Southampton to London Pipeline Project

Responses to ExA's Further Written Questions -
Queen Elizabeth Country Park (QE)

Application Document: 8.42

Southampton to London Pipeline Project
Response to the Examining Authority's Further Written Questions – Queen Elizabeth Country Park (QE)

Appendix QE.2.7.1: Works Plans - Addition of Queen Elizabeth Park Access (Sheet 35 & 106)

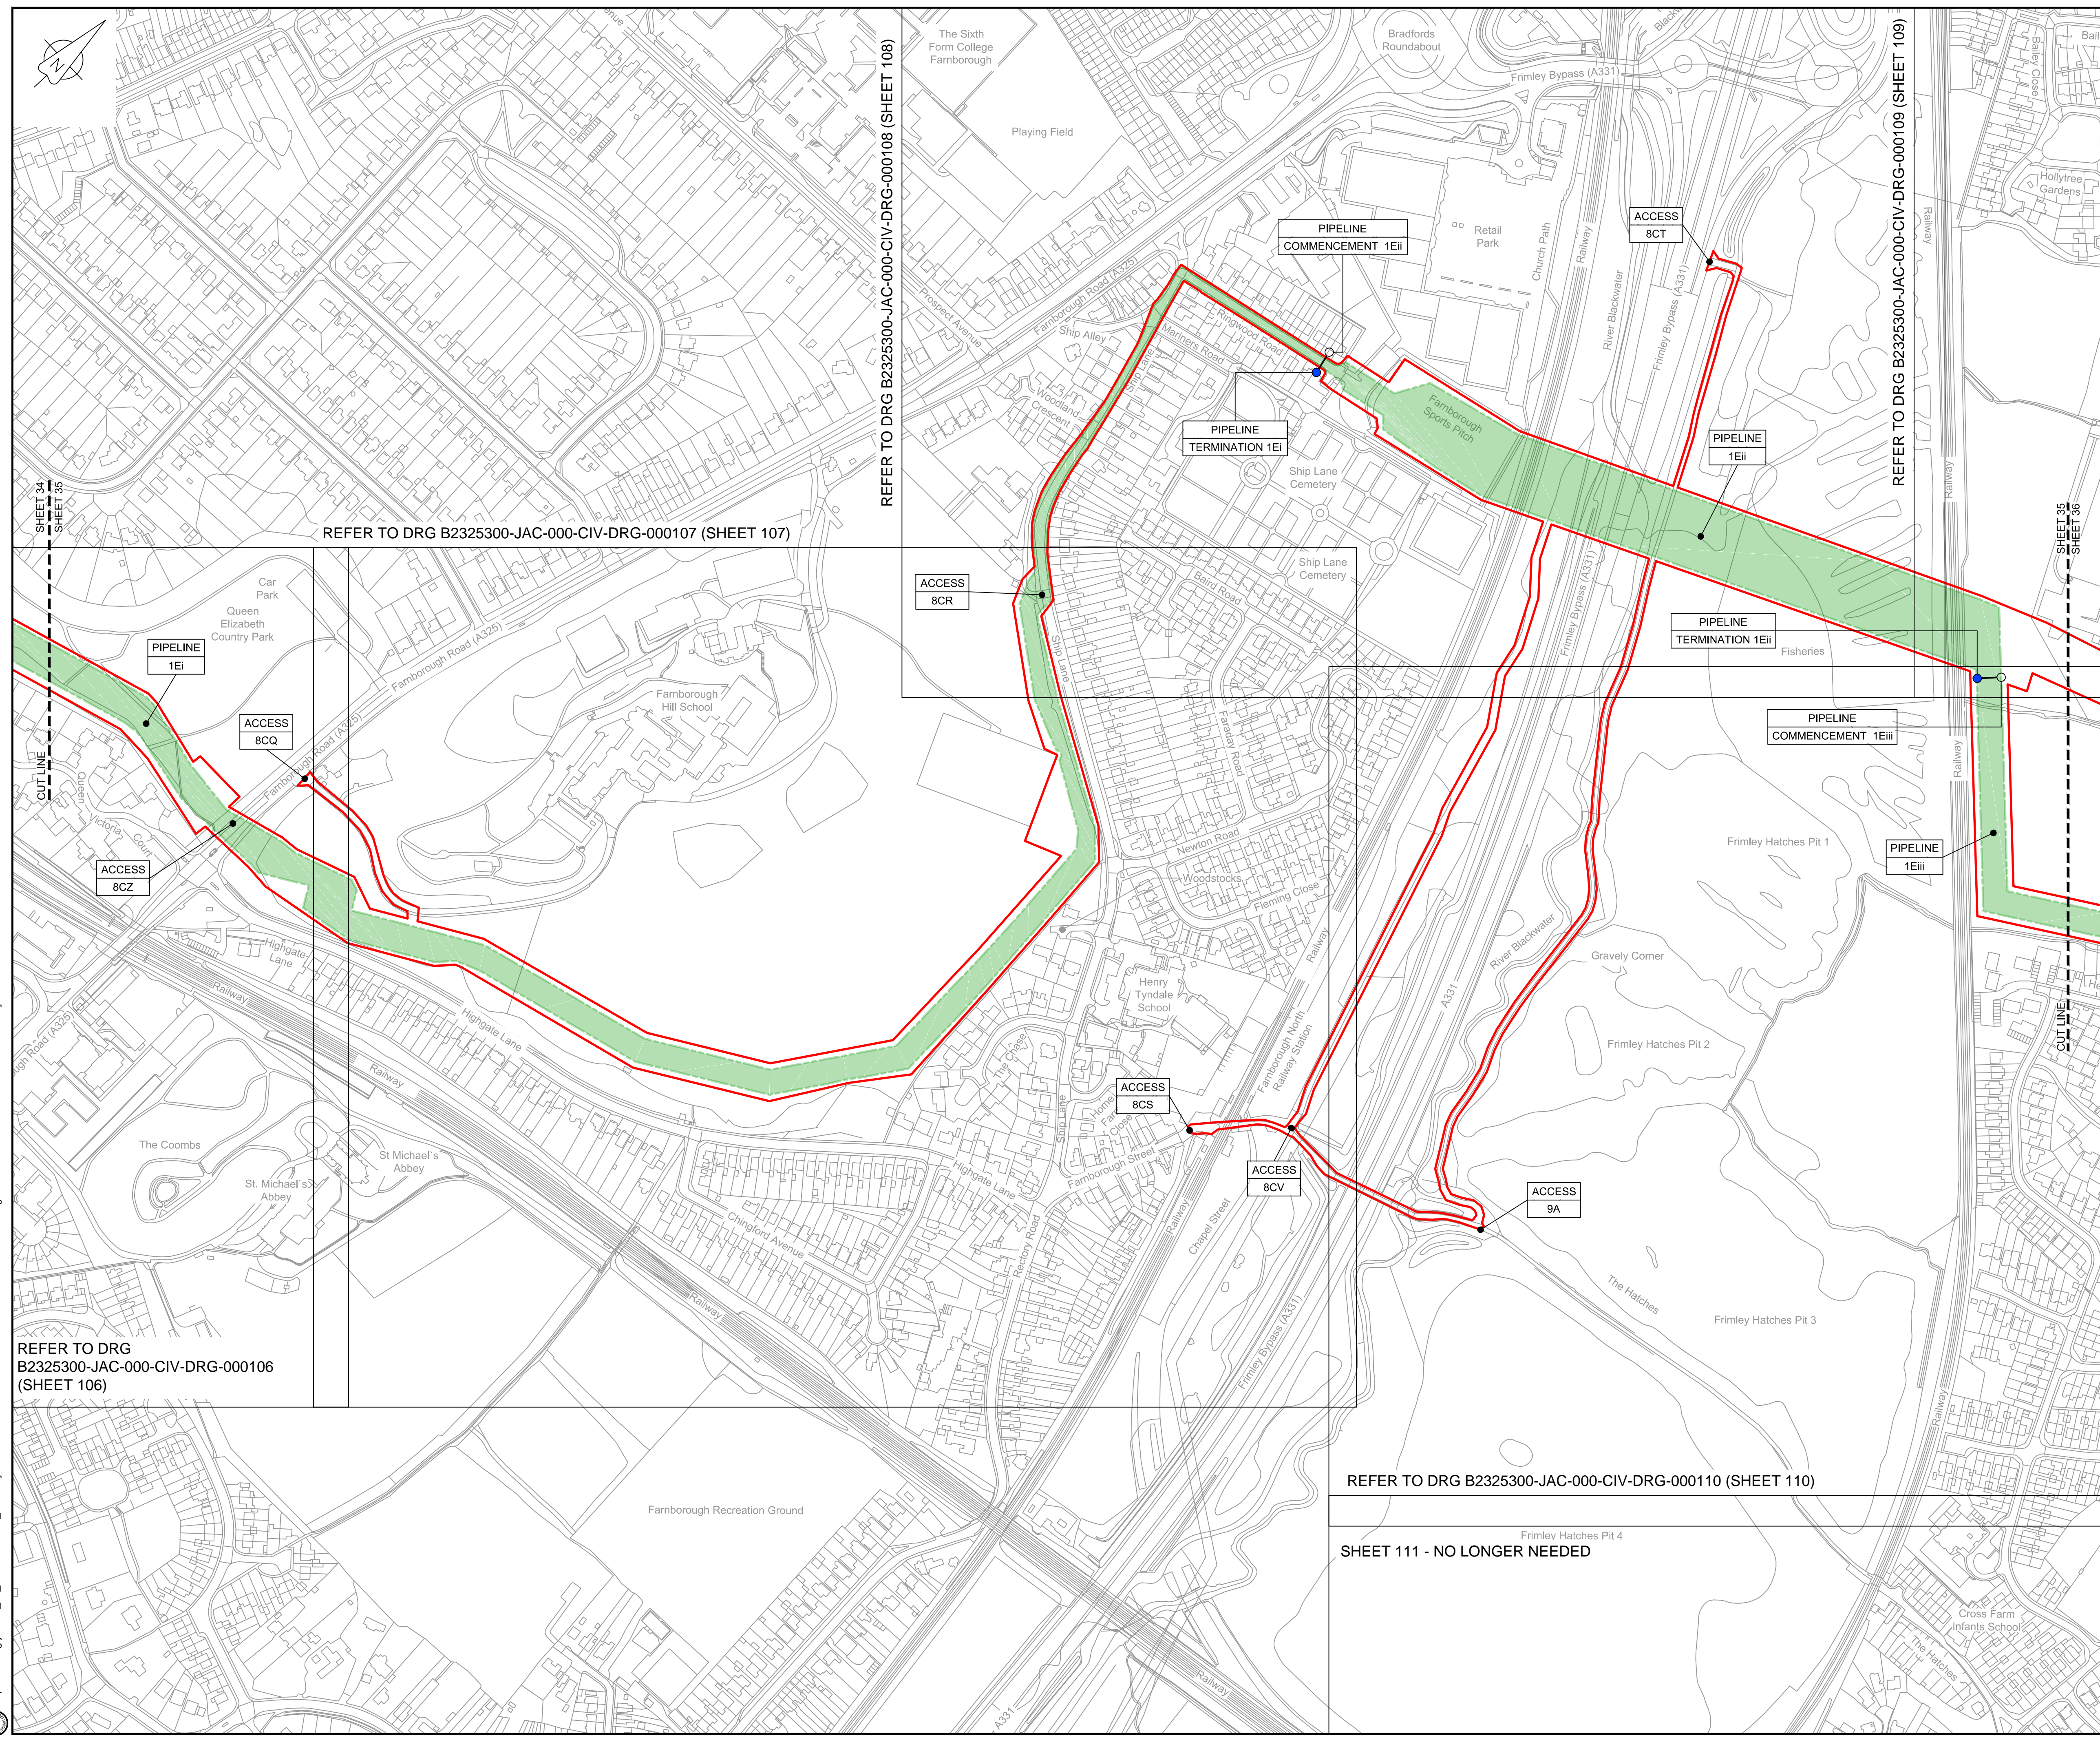
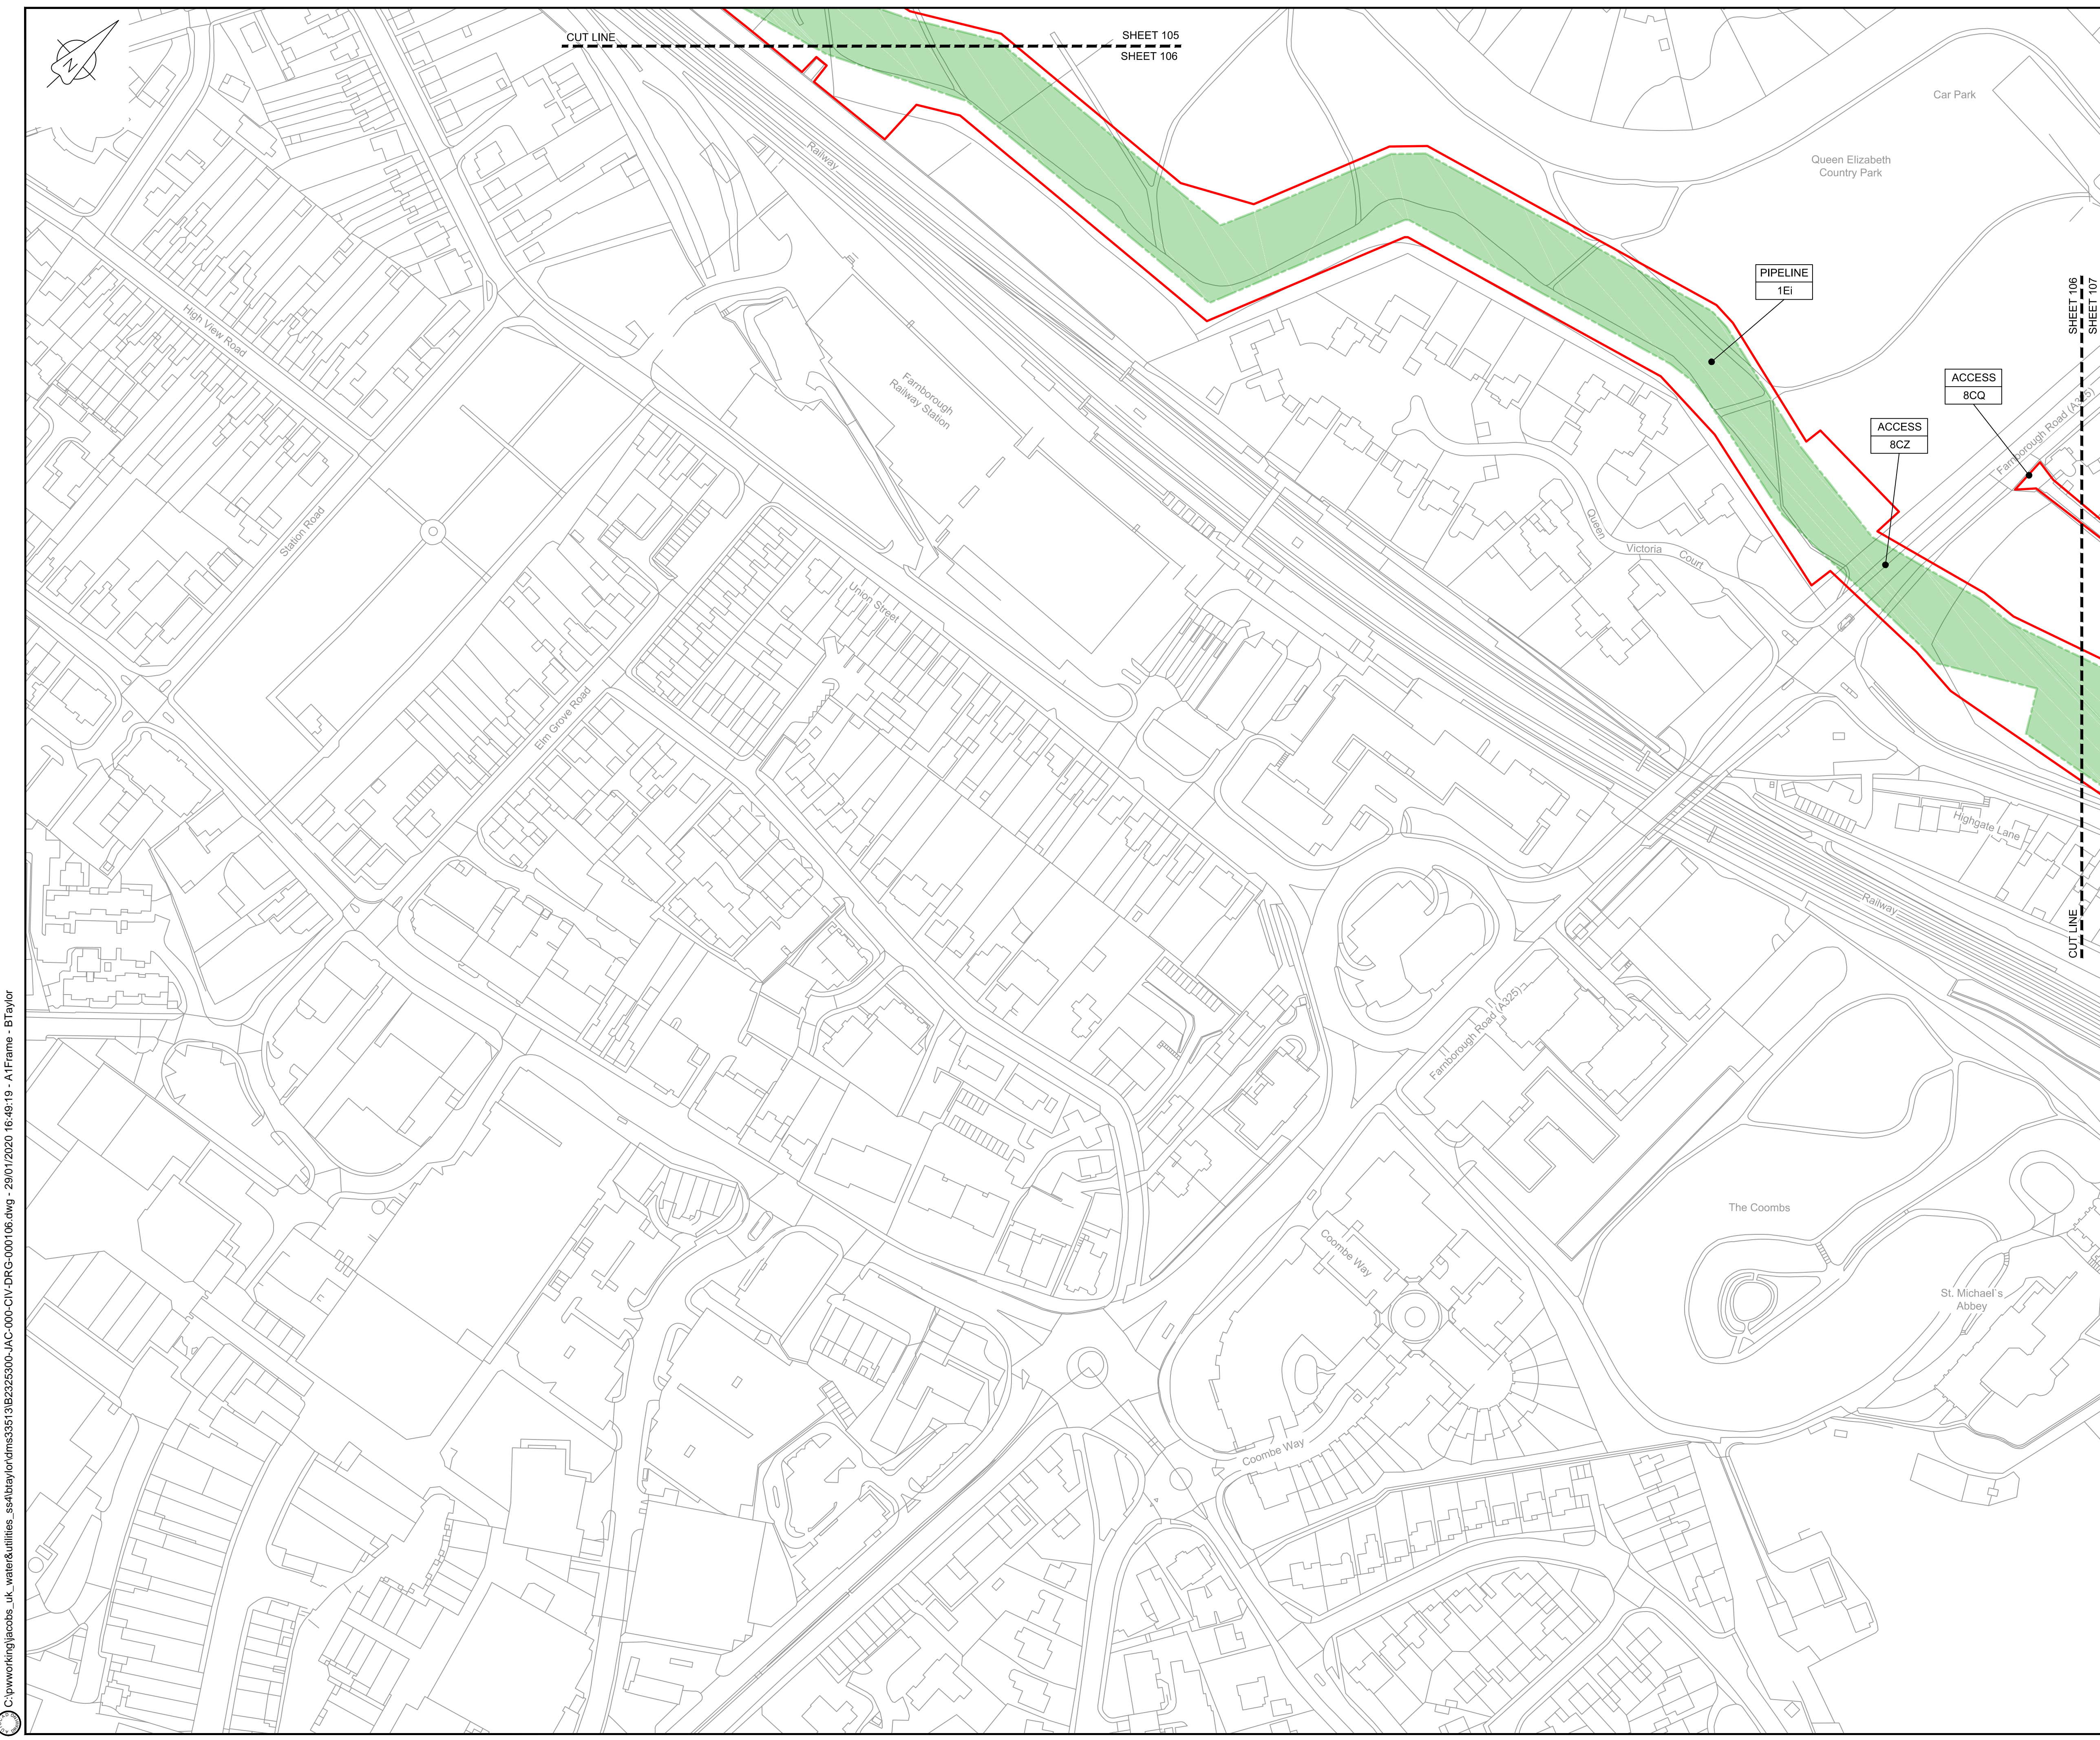
ExQ2	Question:	Applicant response to Question:
QE.2.7	<p>Figure 1.5 of the Applicant's responses to Other Parties submitted at D3 [REP3-017] indicates the proposed temporary access from Farnborough Road to the auger drill compound in Queen Elizabeth Country Park. This proposed temporary works access has been added to the dDCO [REP3-006] but is not shown on the relevant Access and Public Rights of Way or Works Plans.</p>	<p>1.1 The Applicant confirms that the proposed temporary access (Work No 8CZ) from the A325 – Farnborough Road to the auger bore area is now shown on the Work Plans and Access and Public Rights of Way Plans (See Appendix QE.2.7.1 and QE.2.7.2).</p>

C03	09/09/19	SHEETS 10, 11 AND 34 REVISED TO WITHDRAWN A25 SUB-OPTION	BT	JA	ND	NJ
C04	29/01/20	UPDATED FOLLOWING LAND OWNER DISCUSSIONS AND TO ADDRESS FWQs	BT	JA	ND	RS
Rev	Rev. Date	Purpose of revision	Drawn	Checked	Rev'd	Appr'd
